Opinions on SKB's Safety Assessments SR 97 and SFL 3-5

A Review by SKI Consultants

SKI Report 00:47

The Swedish Nuclear Fuel and Waste Management Co. (SKB) has presented their safety assessment "Deep repository for spent nuclear fuel, SR 97 – Post-closure safety". SKB's report is part of the documentation that has been required by the Government before the start of site investigations.

Figure 2. Concentration of $H_2(aq)$ as a function of the liquid level (h_l) in the annulus.

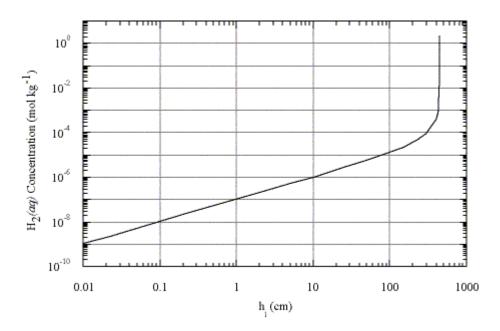
The stability of minerals in the system FeO-Fe₂O₃-H₂O is shown in Fig. 3 as a function of pH over the range of H₂(*aq*) concentrations plotted in Fig. 2. As can be seen, magnetite is stable over most of the range of possible H₂(*aq*) molalities that could exist in the annulus, except when $m_{\text{H2}(aq)}$ is less than about 10^{-8.6} mol kg⁻¹. This corresponds to liquid levels in the annulus less than about 0.1 cm (see Fig. 2).

Hematite is predicted to be stable if $m_{H2(aq)}$ is less than about $10^{-8.6}$ mol kg⁻¹. Hematite is kinetically inhibited from precipitating from aqueous solutions at low temperatures, however, and it is therefore likely that a metastable solid such as goethite would form in its place. If so, the lower limit of magnetite stability is shifted to lower values of $m_{H2(aq)}$ (e.g., about 10^{-12} mol kg⁻¹ for the case of goethite), and thus to smaller values of h_l .

Figure 4. Stability relations among minerals in the FeO-Fe₂O₃-CO₂-H₂S-H₂O system at 25°C (log $a_{Fe2+} = -4.8$; log $f_{CO2(g)} = -3.5$; log $f_{H2S(g)} = -7.8$).

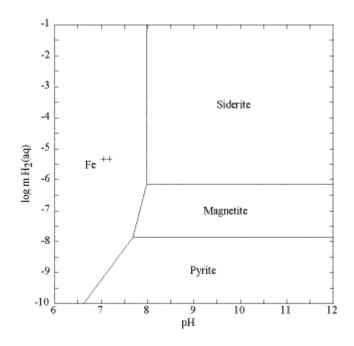
As can be seen in Fig. 4, the stability range of magnetite with respect to $m_{H2(aq)}$ (and thus h_l , see Fig. 2) is significantly reduced compared with that shown in Fig. 3, and is bounded by the stability fields of siderite (FeCO₃) and pyrite (FeS₂). Both these minerals are known to

precipitate relatively rapidly at low temperatures, and their existence as stable corrosion products of iron must therefore be assumed if liquid levels in the annulus are in the appropriate range. As can be inferred from Figs. 4 and 2, corrosion of the insert to form magnetite can only occur if the liquid phase in the gap rises to a height between about 0.1 and 10 cm. The relative stability of magnetite increases at the expense of siderite when $P_{\text{CO2}(g)}$ decreases. It increases at the expense of pyrite when $P_{\text{H2S}(g)}$ decreases. Because maximal partial pressures of both these gases are assumed, the consequent shrinkage of the magnetite stability field relative to that shown in Fig. 3 probably represents the maximum possible extent under repository-relevant conditions.

The assumption adopted in the hydromechanical model that magnetite is the only stable corrosion product of iron is thus open to question. Magnetite, siderite and/or pyrite may be stable depending on the molality of $H_2(aq)$ and the partial pressures of $CO_2(g)$ and $H_2S(g)$. The chemistry of porewater in the buffer, and possibly of groundwater in the nearby host rock, and mass-transport and mass-transfer processes near the porewater-gas interface must be taken into account before reliable predictions can be made concerning which of these phases is the stable corrosion product of iron.

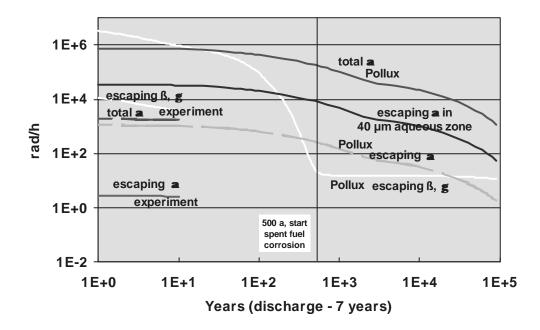
Since radiation level and dose ratio $\alpha/\beta/\gamma$ are different under disposal conditions compared to those in the laboratory the measured corrosion rates cannot be used directly in performance assessment. The surface dose rate after 40 yrs has been estimated as 700 Gy/h, with contributions by beta radiation to about 15%. These values are more than a factor of 10 lower than respective values calculated in a recent EU-project. Particularly, the value for the beta dose rate appears to be very low. It shall be evaluated what is the reason for these differences and a correct value shall be estimated. The contribution of gamma dose appears to have been ignored.

Though the total dose rates expected under disposal conditions are much higher (Figure 1) than in the experiment (both for α and for β , γ) it should be kept in mind, that only a small fraction of α -particles can escape the fuel (19% from 10 μ m escape depth) and in the aqueous phase they can only penetrate to a depth of about 30-50 μ m. Consequently the α dose rate within this 30-50 μ m water layer is the same, both in the experiment and under disposal conditions. After 40 yrs a value of about 400 Sv/h is calculated, a similar order of magnitude as considered in SR 97. In contrast to alpha dose rates, the β - and γ -rates are much higher than those in the experiments. The reason is the high quantity of fuel in a disposal cask. Beta, gamma dose rates in a SR 97 cask are expected to be about half those in Figure 1, due to the lower quantity of fuel. Differences in SR 97 dose rates and those from the EU project are essentially based on differences in the β - and γ -dose rates. Maybe these differences are associated to different radiation attenuation in the canister (an iron insert is not present in the Pollux cask).

Figure 2: Schematic illustration of the effect of geochemical variables on the comparison of the rates of unirradiated UO_2 with that of spent fuel.

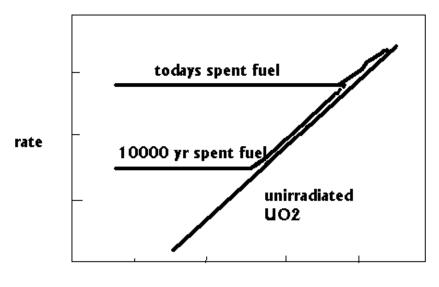
The fuel matrix dissolution rates in SR 97 appear to be considered to be independent of temperature and geochemical variables such as pH, pCO₂, Eh. The only condition considered appears to be the assumption of overall reducing conditions. This approach may be valid in part for recently discharged fuel with high radiation fields. Radiolysis can mask effects of temperature, pH, Eh and pCO₂. This can be shown by a comparison of spent fuel leach data with those of unirradiated UO₂. However, data for dissolution rates of UO₂ and of spent fuel under oxidizing conditions seems to indicate that the major difference is the specific surface area. Such an investigation has not yet been conducted for reducing conditions. Here corrosion rates of spent fuel are much higher than those of UO₂, due to radiolysis effects. It is difficult to distinguish between radiolysis effects and higher reactivity of surface sites. Nevertheless, such distinction is necessary for a model of spent fuel dissolution based on the behaviors of unirradiated UO₂.

The schematics of the masking effect of radiolysis are illustrated by Figure 2. There is probably a critical concentration or a critical temperature below which spent fuel properties in contrast to UO_2 properties become independent on these geochemical variables. If a particular geochemical parameter value would lead to rates of UO_2 dissolution higher than those of irradiation assisted dissolution of spent fuel, a corresponding increase in spent fuel corrosion rates might be expected. The more the radiation decays the lower the rates become, and consequently the lower is the critical temperature or critical concentration. Thus, the more important are these variables as controls of the dissolution rate. There is a relationship between the reaction order of UO_2 dissolution rates and other environmental variables apart from radiation. It is not yet possible to account for the potential environmental effects on fuel corrosion rates under reducing conditions, but from data of unirradiated UO_2 it is clear that a model only based on radiolytic oxidant concentrations such as the one proposed in SR 97 is insufficient. Certain observations are illustrated in the following:

Temperature: The effect of temperature on the oxidative dissolution process of unirradiated UO₂ suggests activation energy values between 20 - 60 kJ mol¹ (Gray et al. 1992, Grandstaff et al. 1976, Hiskey 1979, Aronson et al. 1957). De Pablo et al. (1997) have performed dissolution experiments as a function of temperature. The apparent activation energy calculated was 49.5 ± 16 kJ mol¹ in the range between 10 – 60 °C, This value is much higher than the value determined with spent fuel (Gray et al. 1992). Leaching experiments performed with spent fuel under oxidizing conditions have shown no differences on radionuclide release at temperatures lower than 150 °C. However, an effect of temperature was observed at higher temperatures.

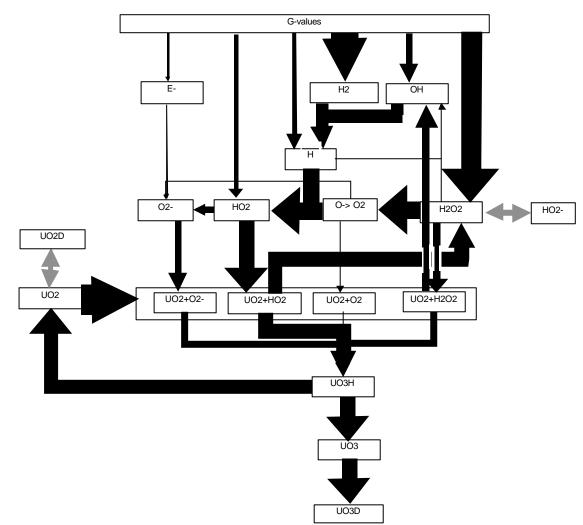
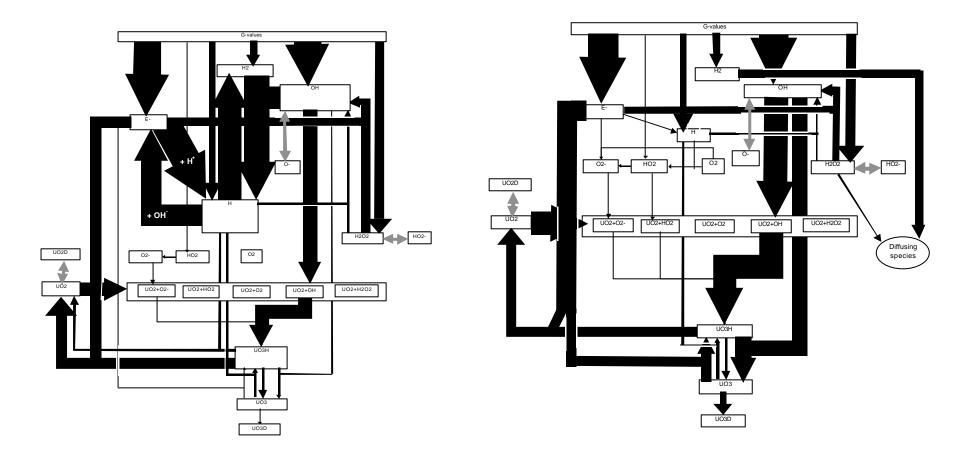
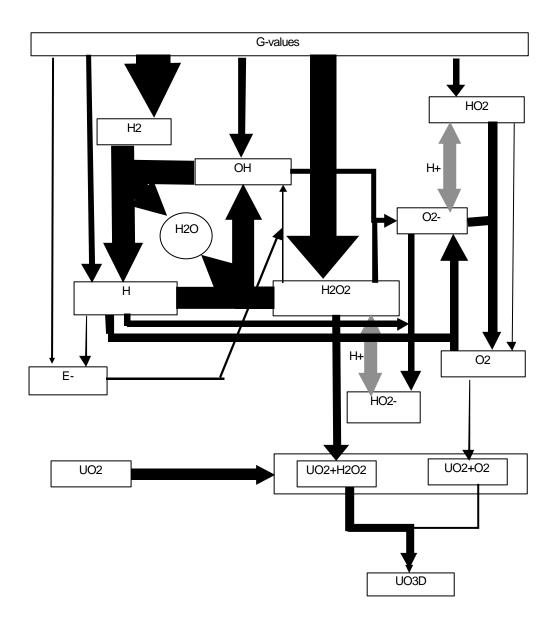
What is the reason for the much lower H radical concentrations in the Christensen model for alpha radiolysis enhanced fuel dissolution? When comparing Figure A2 with Figure A3 and A4 it becomes obvious, that the decomposition of H_2O_2 into O radicals and their recombination product O_2 is the cause. This reaction occurs also in the absence of irradiation. This reaction was suggested by Shoesmith to simulate the catalytic decomposition of H_2O_2 on the surface of UO_2 (Christensen, personal communication). This reaction is not considered in the Eriksen model. It can be see from a comparison of Figures A1 and A2 with Figure A5 that O_2 is considered in the two models as a strong scavenger for H radicals. The more O_2 is generated, the more H radicals are consumed. Long-term O_2 concentrations are about 10 orders of magnitude lower in the Eriksen model when compared to the long-term Christensen model.

Fig. 1 Breakthrough curves at x = 500 m for the migration of a non-sorbing element due to a constant concentration at x = 0 and zero initial concentration. All of the parameter values have been taken from SKB's report and are described in the text.

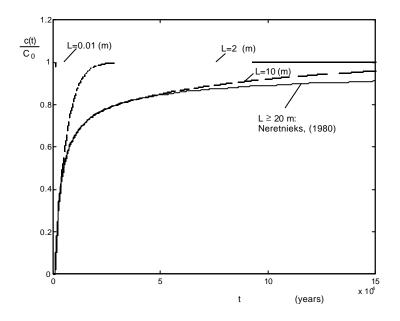
If it is assumed that the maximum penetration depth is 10 mm instead of 20 meters, the residence time, according to (2) will be about 100 longer than that predicted by (1). Figure 1 shows penetration curves using different assumptions for maximum penetration depth for a constant boundary concentration. All parameter values are taken in accordance with section 9.9.7 of SKB's report: $a_w = 1000 \text{ m}^{-1}$, x = 500 m, $D_e = 3x10^{-6} \text{ m}^2/\text{year}$ and $q = 2x10^{-3} \text{ m/year}$. These values can be converted into a fracture aperture = 2 mm and a flow rate in a rock fracture of 1 m/year (assuming a fracture frequency of 1 per m). Since the concentration at x=0 is kept constant, the concentration at x=500 m approaches this value with an increase in time. We can see that 90% of the final concentration is obtained after time $t_{90\%} = 830$ years when the maximum diffusion depth is L=10 mm, t=11,000 years when L=2 and 150,000 years when the penetration depth is more than 20 meters. The total difference in $t_{90\%}$ (200 times) is of decisive importance for the assessment of the impact of the matrix diffusion on the retention of radionuclides in the geosphere. The difference decreases with an increase in sorption affinity within the interval $0.01 < L < \infty$ since the effective diffusivity decreases. In spite of this, realistic measures of the maximum penetration depth are important for the results presented in diagrammatic form on pp. 303 to 320.

SKB should clearly discuss how it intends to treat and technically evaluate such conceptual differences in model concepts that can result in essential differences in conclusions concerning radionuclide transport processes. As with the strategy reported for flow modelling, several different model concepts should be used to describe retention processes (to represent uncertainties in our way of understanding and mathematically describing these processes).

This uncertainty is discussed in the calculation of residence times on p. 278. The conclusion proposes that the travel times for water should be given as t_w. This does not alter the fact that the determination of the radionuclide travel time will still be affected by how the matrix diffusion is quantified. The transport calculation is briefly described on pages 291 and 295 under the heading, FARF31, where SKB states that the matrix diffusion is taken into account as a radionuclide retention process but does not state exactly which model assumptions are made.
